ADDEUNDUM 1 RFP 2526-001 Central Offices A&E

NMPS CENTRAL OFFICES
FIRST FLOOR
GREEN AREAS PHASE 3

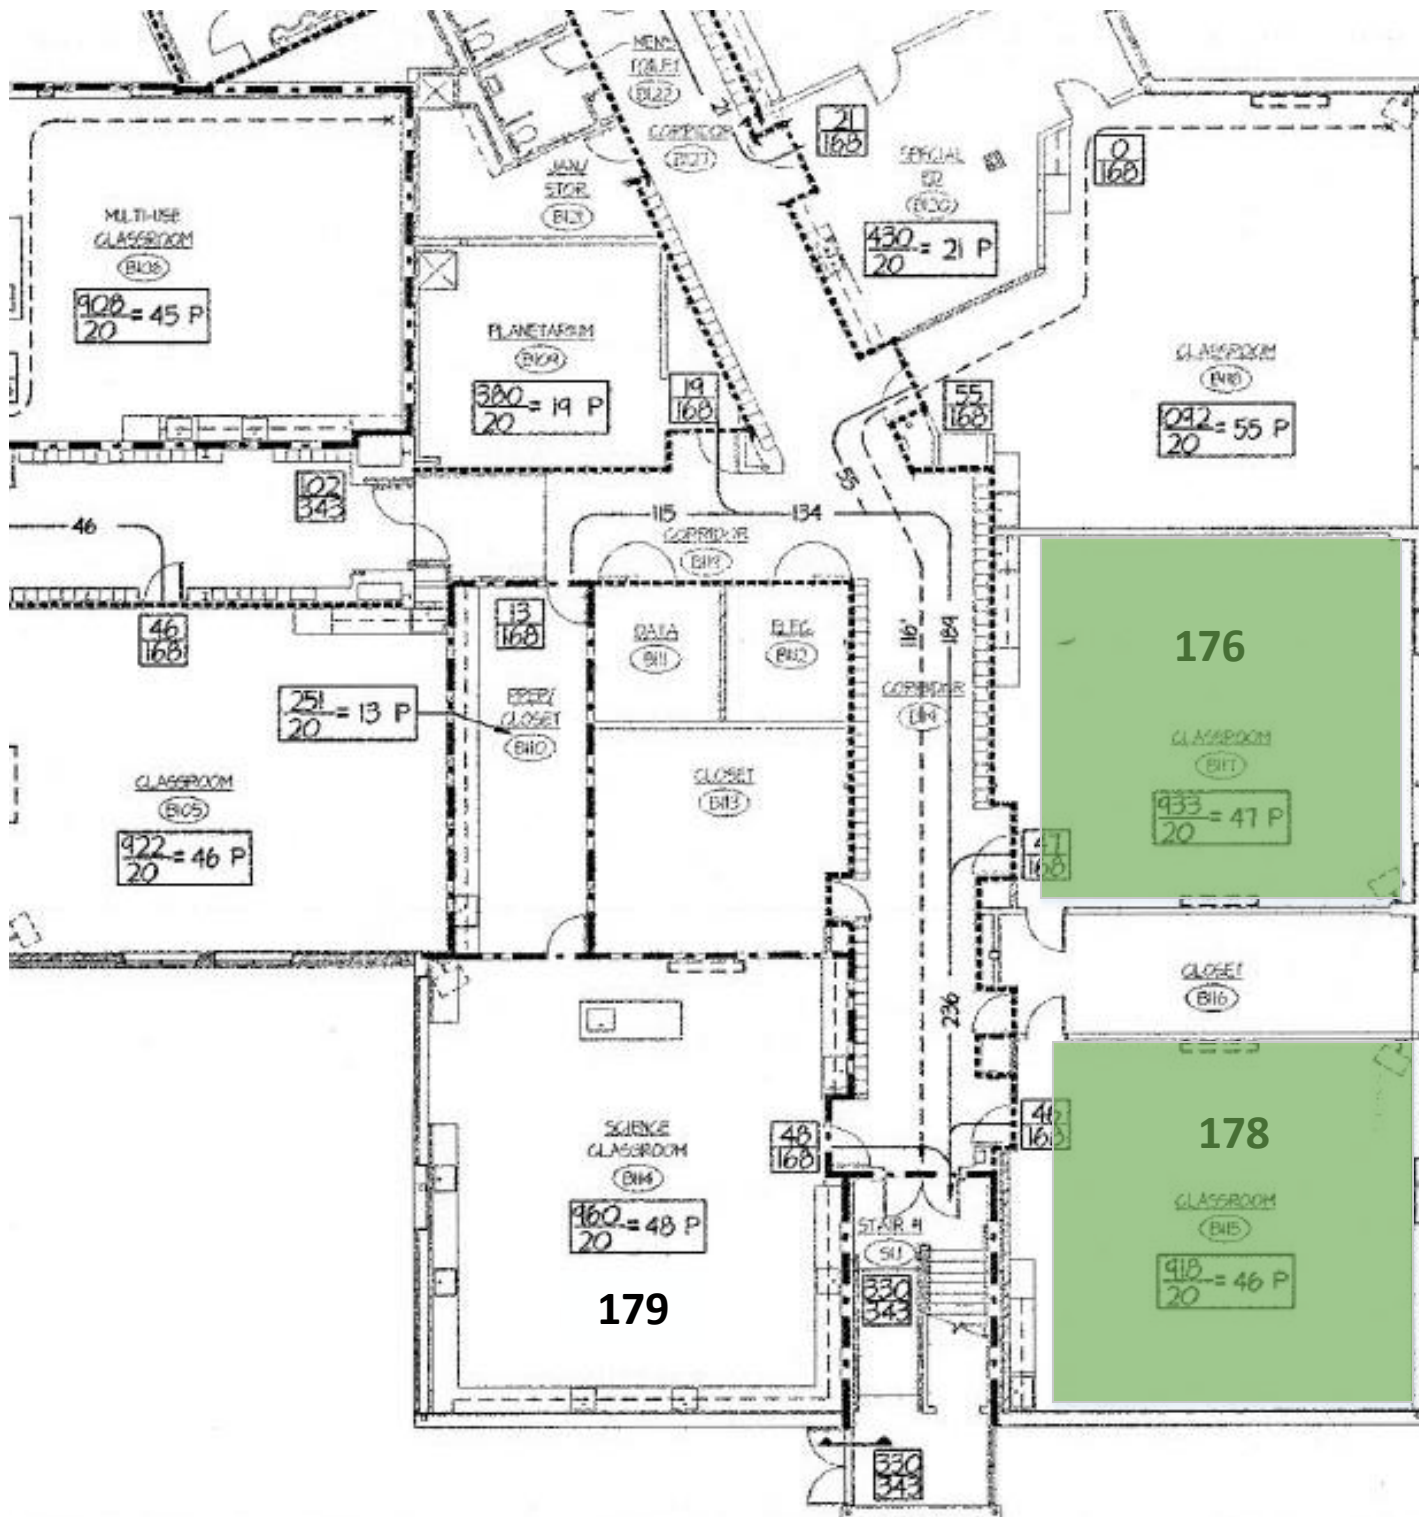
Can drawings that identify the areas and phases of construction be provided for reference?

Yes. The requested drawings delineating the construction areas and associated phases are included as attachments to this RFP addendum.
